DEPARTMENT OF PLANNING AND PERMITTING
CITY AND COUNTY OF HONOLULU

Subject: Plan Review Use (PRU) Permit
Chapter 343, Hawaii Revised Statutes (HRS)
Environmental Assessment (EA) Determination
Finding of No Significant Impact

FINAL ENVIRONMENTAL ASSESSMENT

Electrical Systems Upgrade Project

Figure 4
GENERATOR BUILDING SITE PLAN

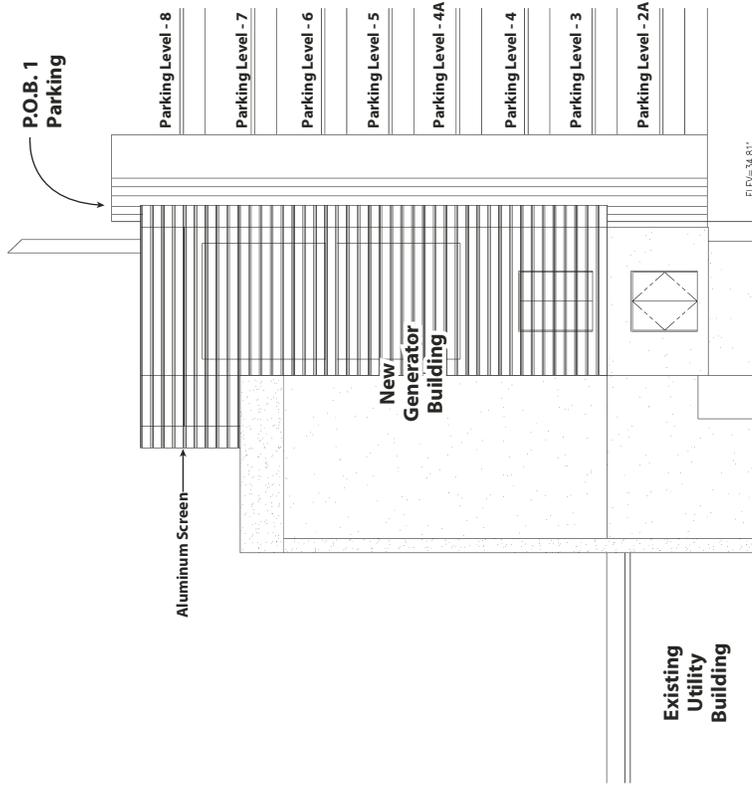
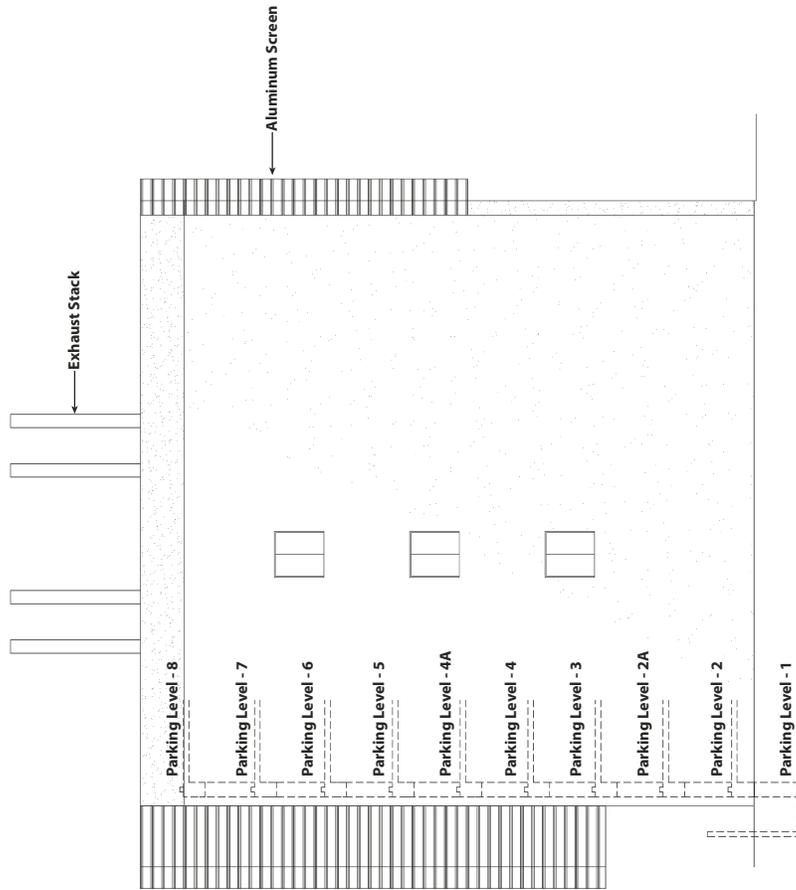
6. What is represented by the cross-hatched area on Figure 4, Generator Building Site Plan? This plan should be fully dimensioned.
7. To ensure compliance with the Land Use Ordinance (LUO), please provide open space calculations and show setbacks on the plans.

The demolition work notation in Figure 4 in the Draft EA indicates a dotted line around three (3) existing generators that were to have been removed. The Queen's Medical Center has decided to keep the existing generators, which will remain in place, to increase the level of reliability of the emergency power supply system. The text on page 3 Section 1.1.1 of the Draft EA states that the existing generators will remain. This demolition notation will not appear in Figure 4 in the Final EA.

- 6. The cross-hatched area on Figure 4 represents the footprint of the proposed new Generator Building. A scaled Site Plan drawing with the new Generator Building dimensioned is included in the Final EA.
- 7. The footprint of the proposed new Generator Building is 2,266 SF and is included in the “Building Area” total below. (These numbers do not include the Miller Street Triangle Lot or the POB2 Lot.) A copy of the August 2007 “Open Space Plan” is attached to this letter. The plans in the Final EA show setbacks. The Open Space calculation for the Queen’s Medical Center Campus is:

Figure 6
GENERATOR BUILDING ELEVATIONS

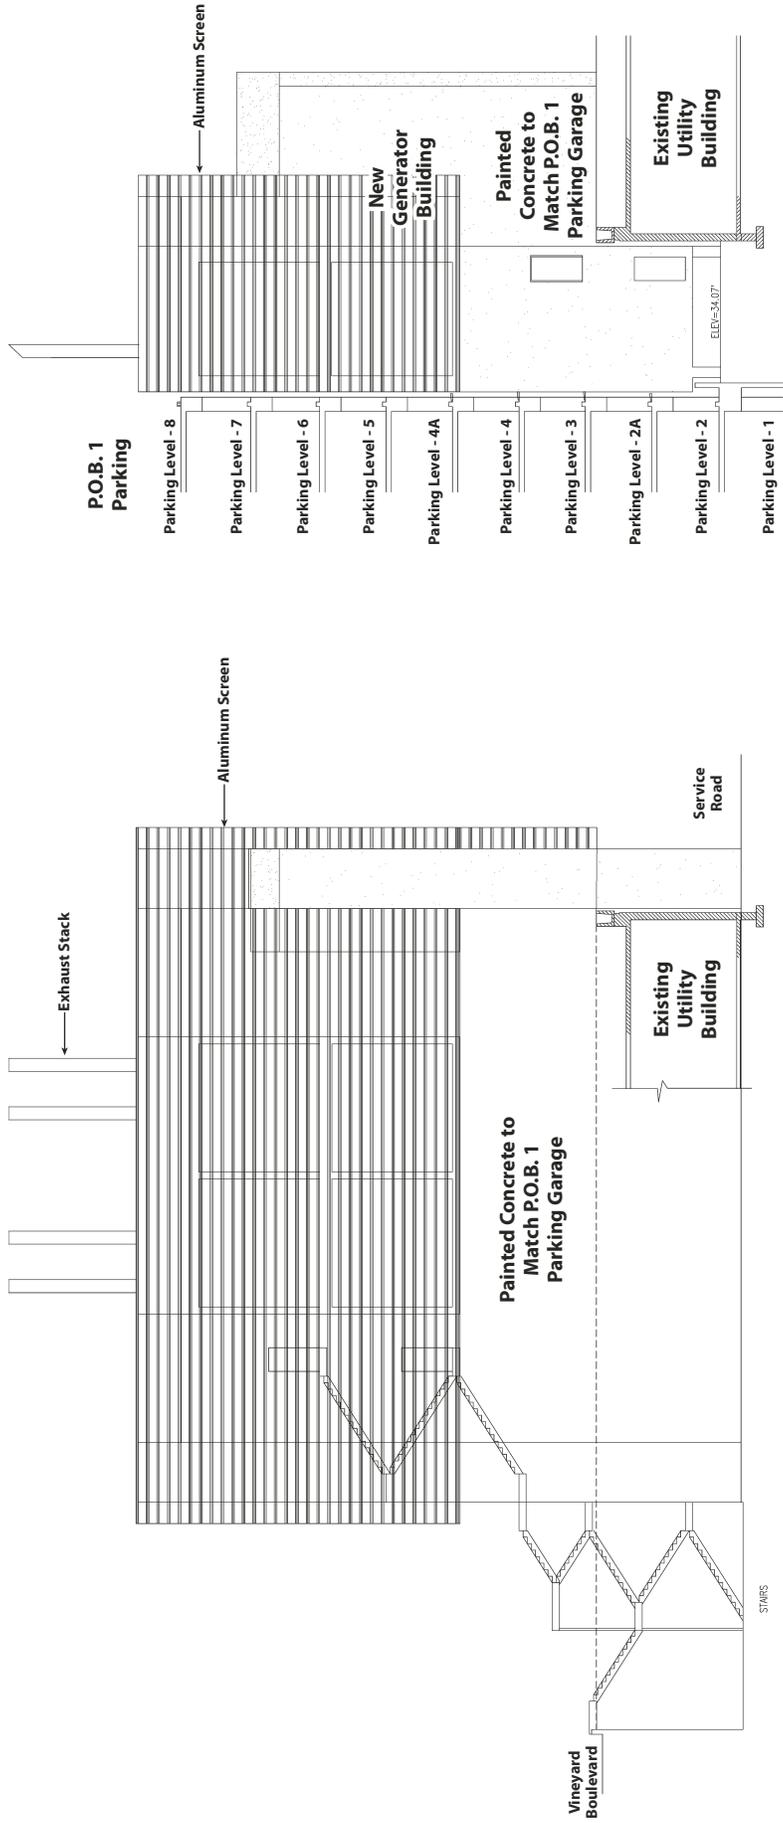
8. As depicted in Figure 6, are the stairs within the setback? Are stairs interior or exterior?
9. The DEA must disclose that the proposal requires approval of a Minor Special District Permit. It appears that the building may be visible from the 5th floor lanais at the State Capital, which is identified as a prominent view within the Hawaii Capital District. Please address this issue.

- 8. As depicted in Figure 6 of the Draft EA, the mauka stairs are on the exterior of the new Generator Building and are not enclosed. The mauka exterior stairs are 29 feet 3 inches away from the closest property line. The exterior stairs are not within any yard setback.
- 9. Chapter 6 of the Final EA will state that a Minor Special District Permit is required.

Figure 8
GENERATOR BUILDING SECTION

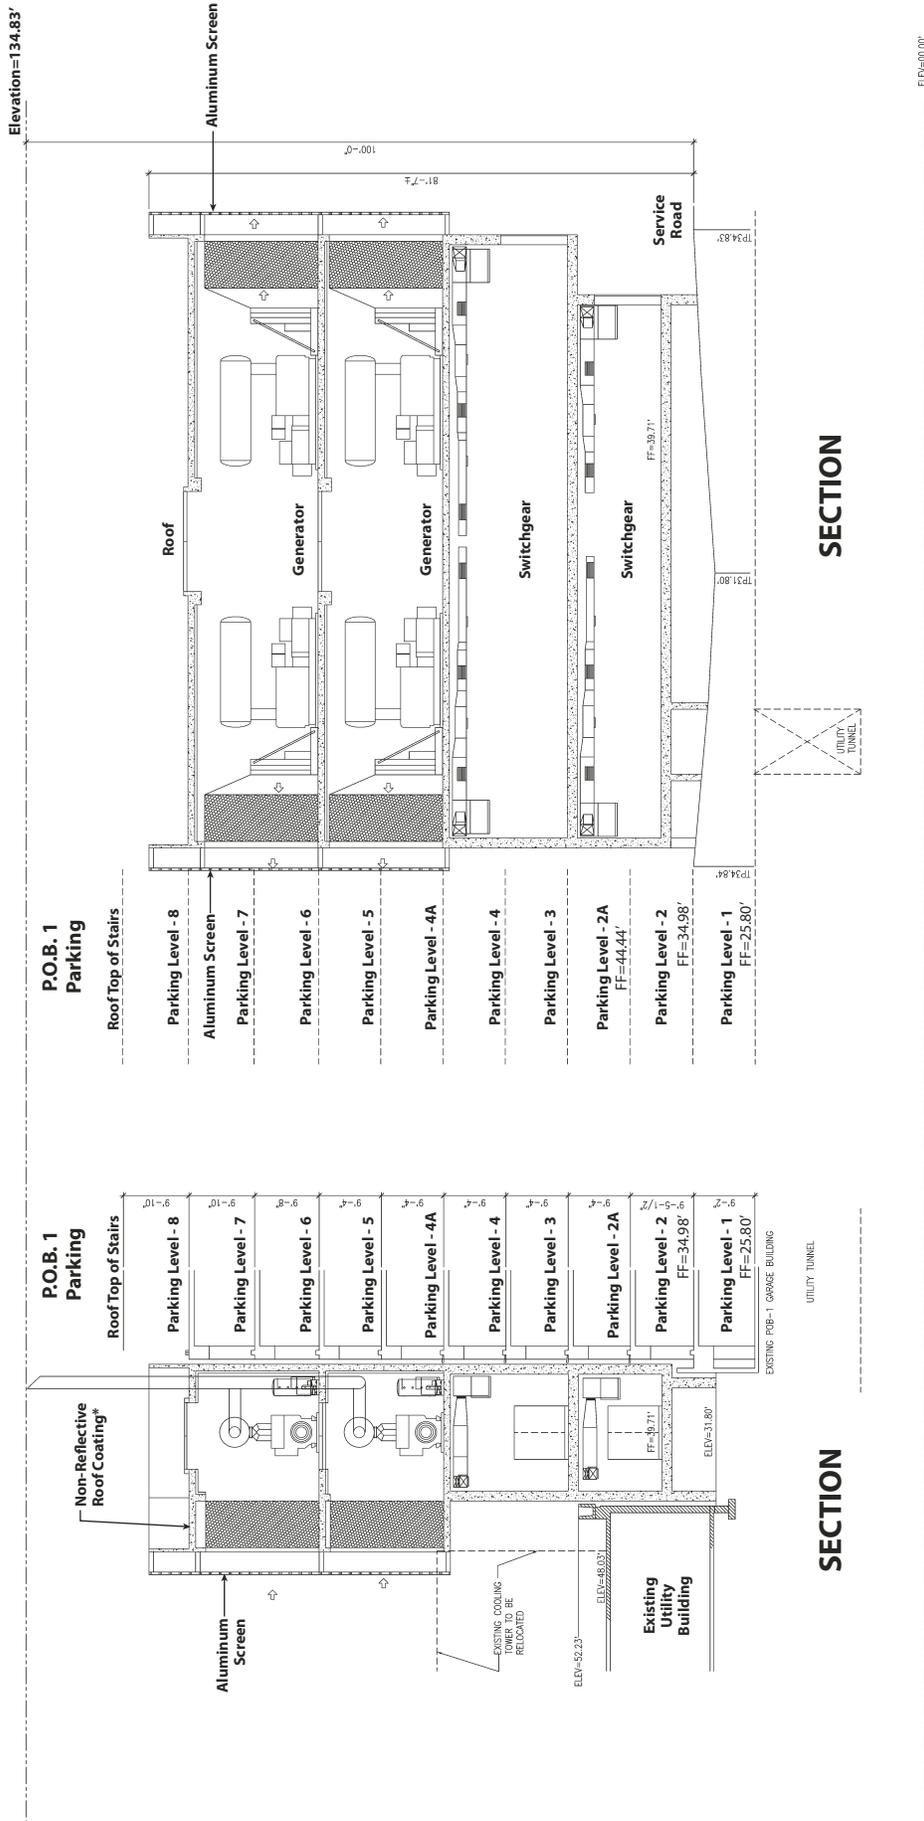
10. On Figure 8, please ensure that the roof color is not white or reflective. There is a notation that the cooling tower will be relocated; where will this occur? Please provide a narrative description and plans.

The roof will not be white and it will not be reflective. Figure 8 in the Final EA will indicate that the roof color is not white and is not reflective. The roof color is intended to be an approved green that will comply with the Hawaii Capital Special District guidelines. It is intended to be a similar shade of green that was used on the Bishop rooftop for the Addition/Alteration of Cath. Lab/New Mechanical Room project, BP 615013.

As depicted in Figure 8 of the Draft EA, the dotted outline of the existing cooling tower is impacted by a portion of the new Generator Building. This is due to the large air intake silencers that are required to ensure adequate noise mitigation measures for the generators. The silencers, which are approximately seven feet in length, impose the need for additional building width, which is achieved by cantilevering the new Generator Building over the existing Utility Plant Building. The existing cooling tower #3 and the existing boiler diesel fuel tank #2 are both impacted by the required cantilever. Therefore, it is necessary to relocate cooling tower CT-3 and the boiler Diesel Fuel Tank 2 elsewhere on the Utility Plant Building roof. A discussion and plans of the Utility Plant rooftop work are included in the Final EA.
